ISSUE	DATE	DRAWN	CHECKED	DESCRIPTION
CLIENT	Grosvenor Propco Limited			
PROJECT	28 Chester Terrace			
DRAWING TITLE	Proposed floor Plans 2nd, 3rd & roof plan			
SIZE & SCALE	A1L 1:50@ A1 1:100@ A3			
DRAWING STATUS	ISSUED FOR LBC

JOB NUMBER	236868
DRAWING NO.	P_03_201
REVISION	E

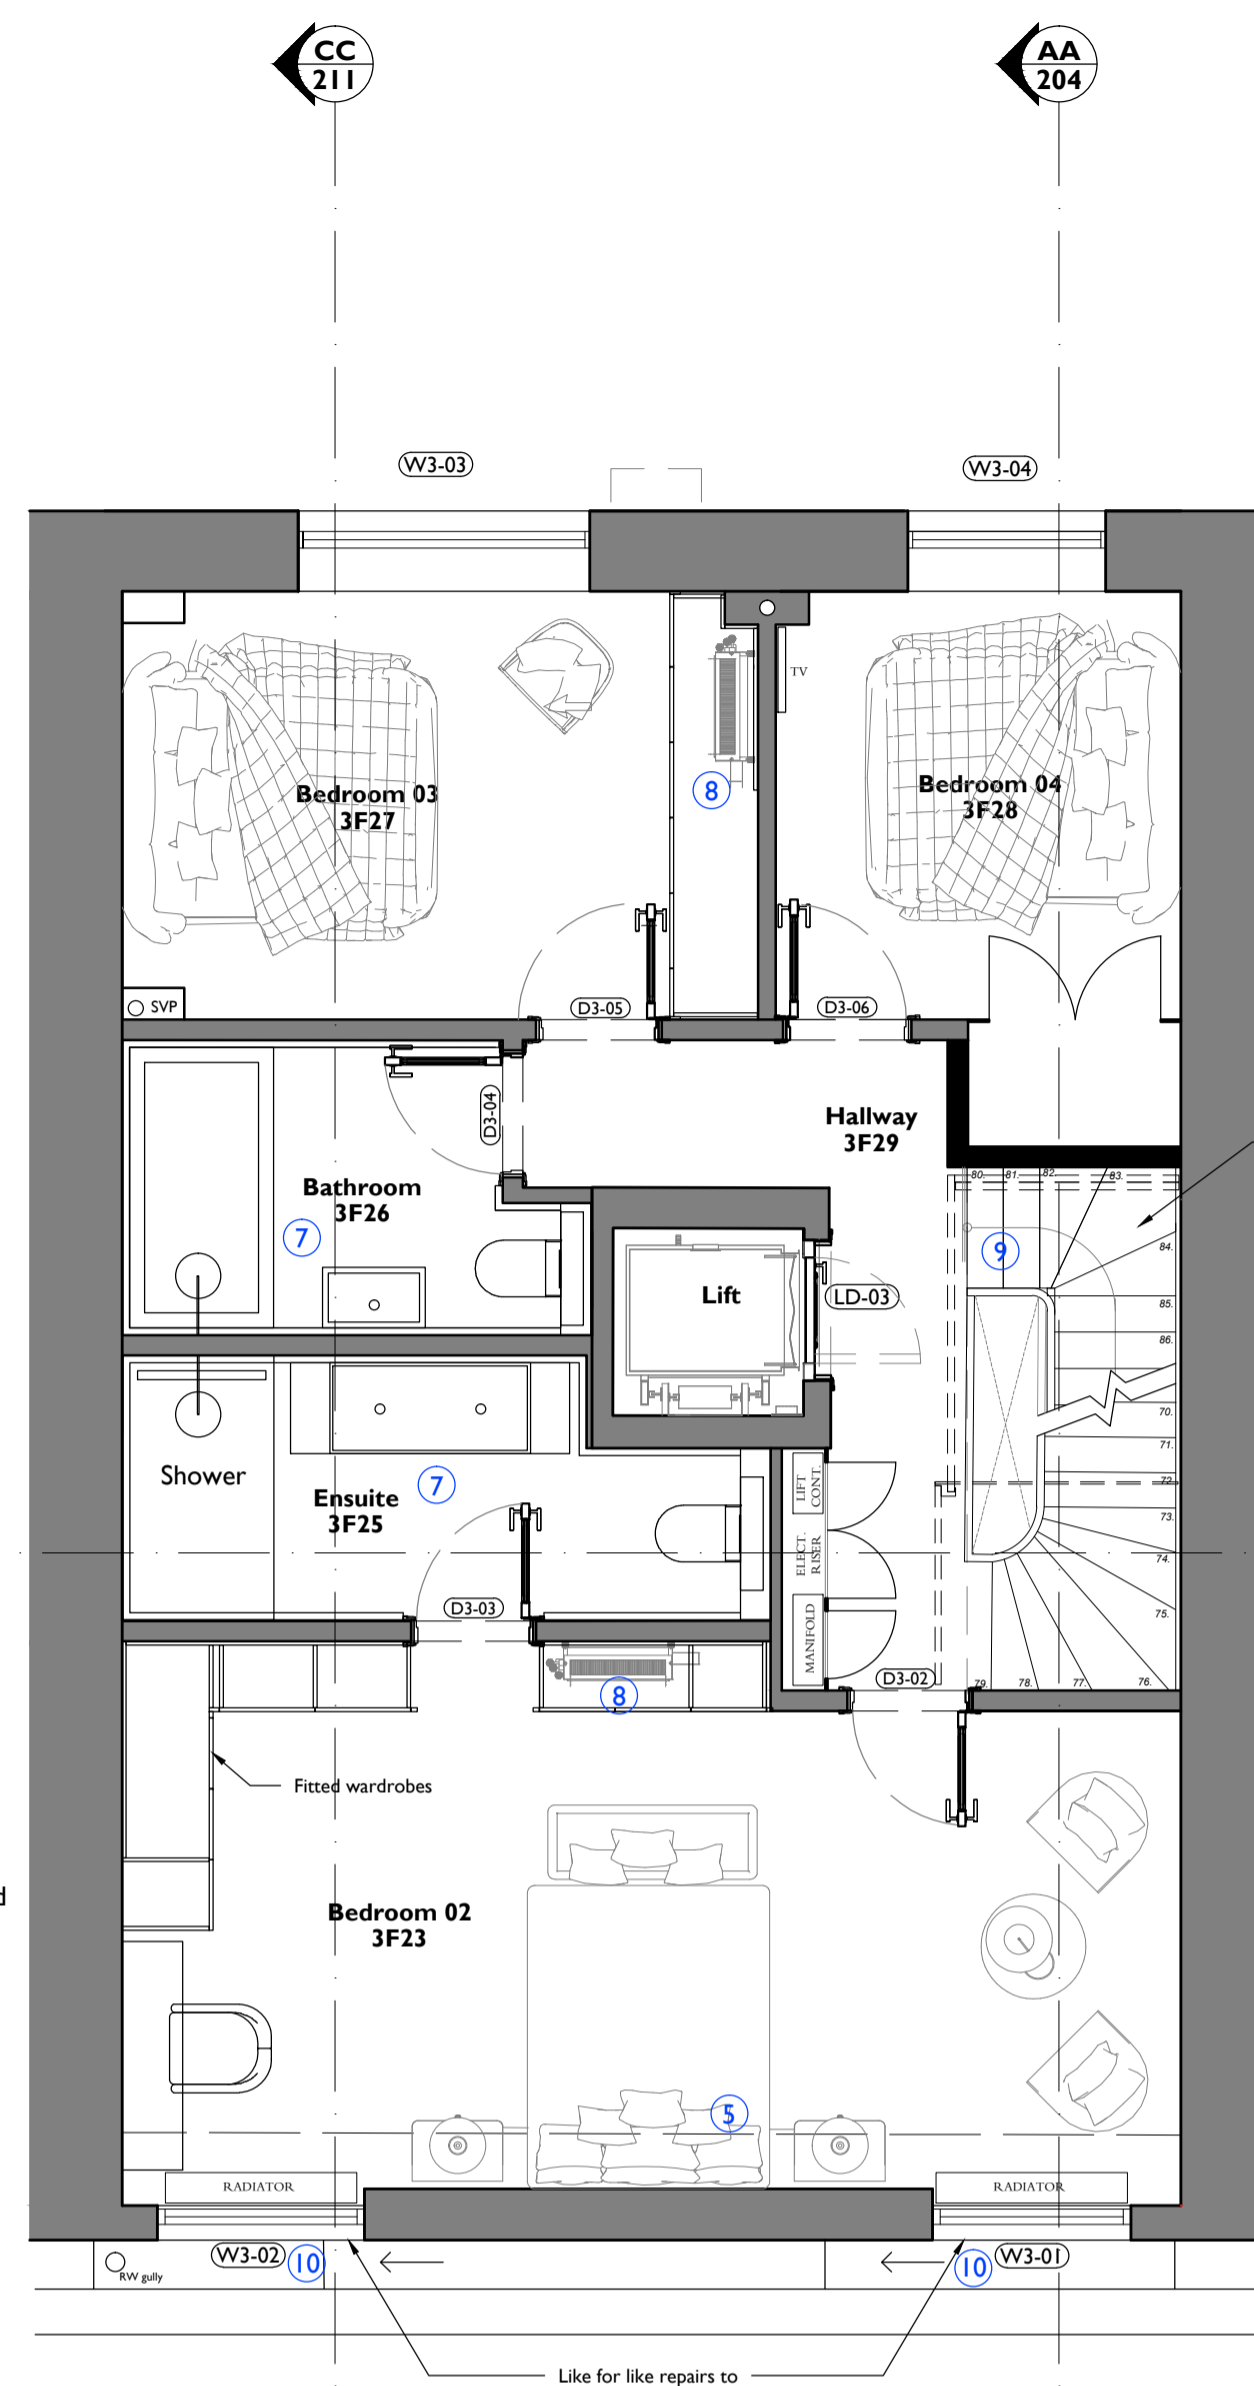
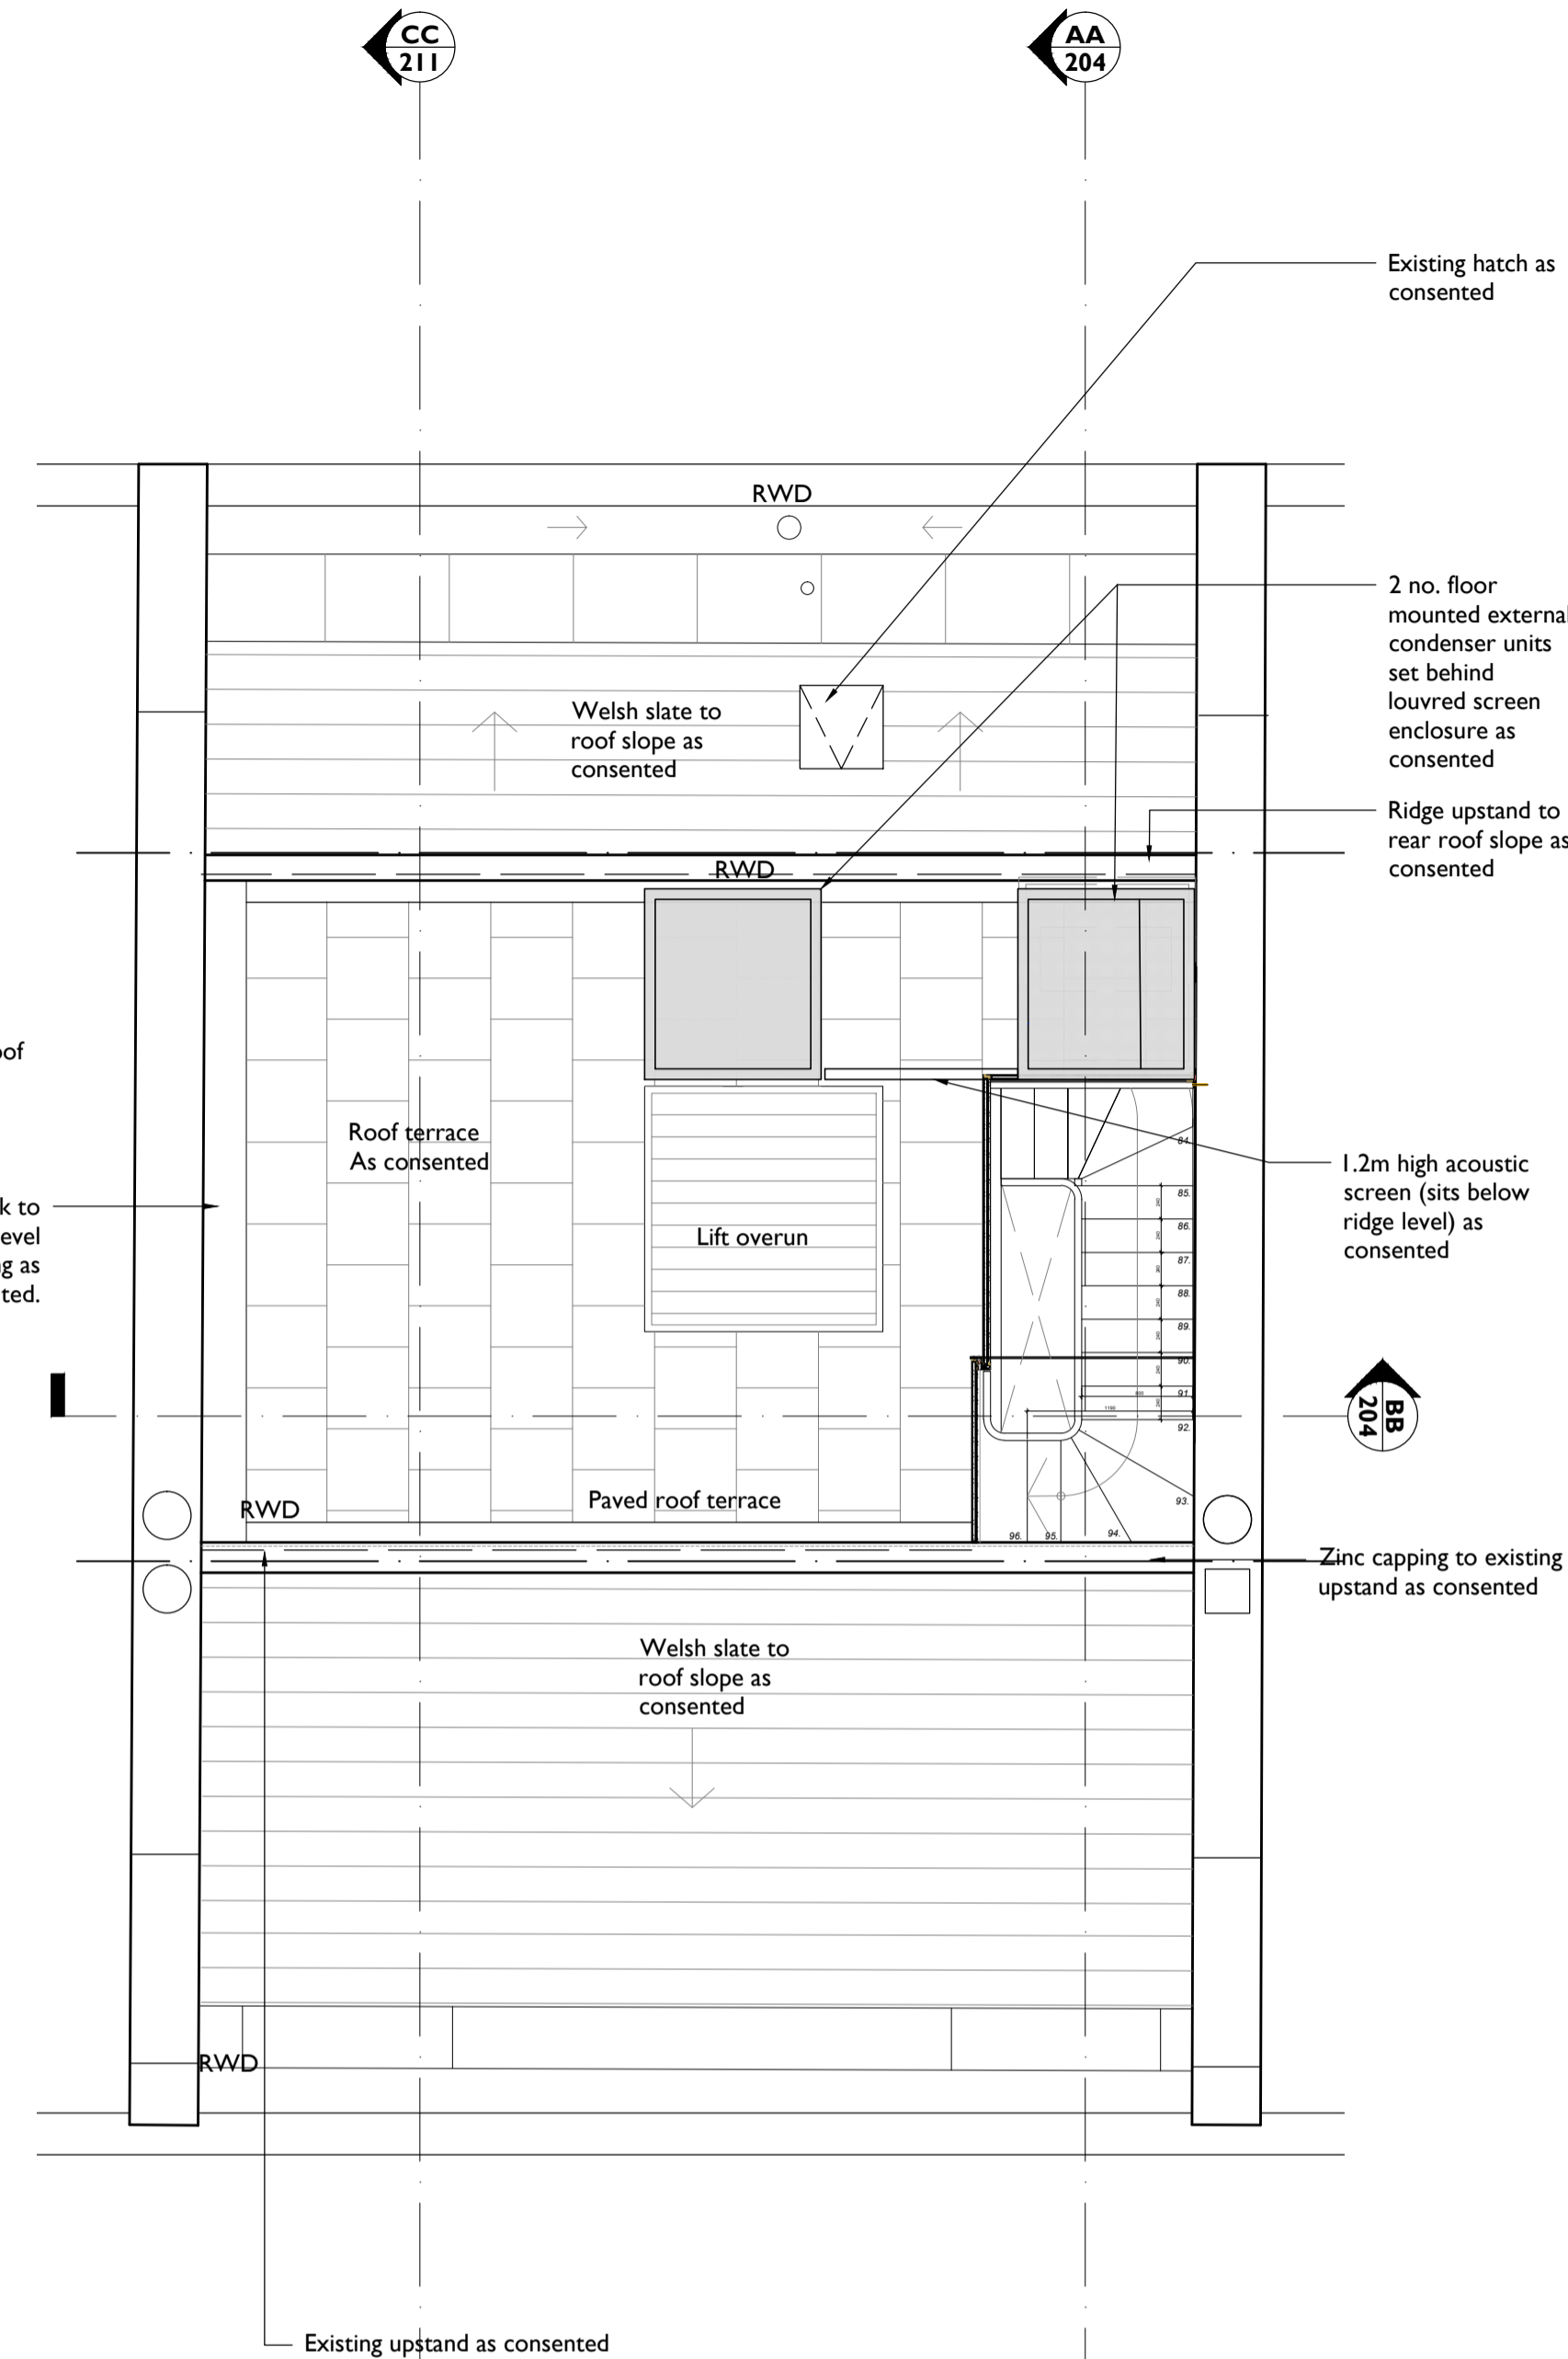
- NOTES:**
- New building fabric
 - [PROPOSED AMENDMENTS TO CONTENTED APPLICATION 2017/1438/P](#)
 - ① Pocket doors to replace consented side hung doors.
 - ② Bathroom partition layout revised to provide recess for WC
 - ③ Master Bathroom shower + WC layout revised.
 - ④ Door to access consented riser
 - ⑤ Under-stair cupboard layout revised.
 - ⑥ Nibs to opening increased in length
 - ⑦ Bathroom layouts revised
 - ⑧ Floor studding fan-coil unit within decorative joinery
 - ⑨ Proposed consented stair to Roof Terrace, winding stair introduced to maintain headroom over stairs
 - ⑩ Like for like repairs to third floor sash windows
